Wayne Wright, W5XD
Directional Coupler

Rev 1.0
10/15/2023

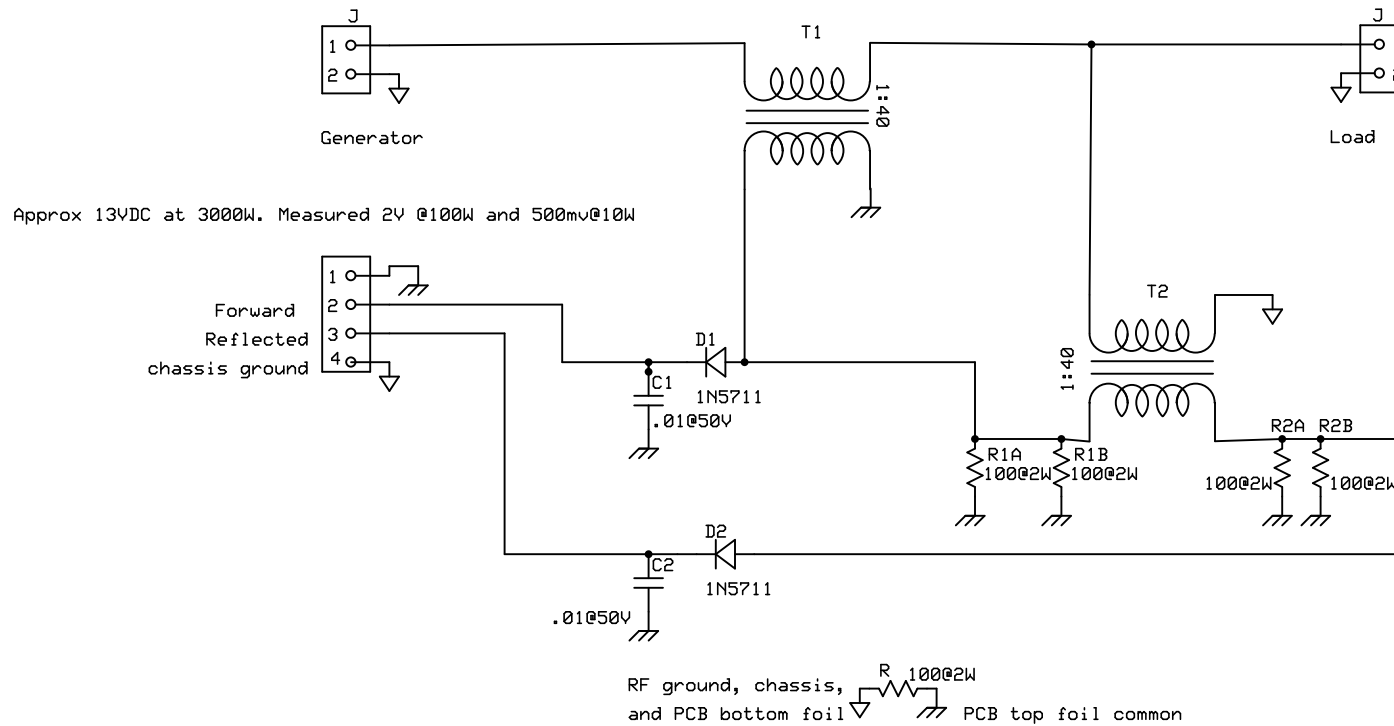
Exception: REV01 of the PCB has the 40T holes placed such that Forward and Reflected are reversed at the output

Fix this either by:

- reverse one of the transformer's wires to their opposite holes on the PCB OR
- wind the second transformer in the opposite direction when you construct it.
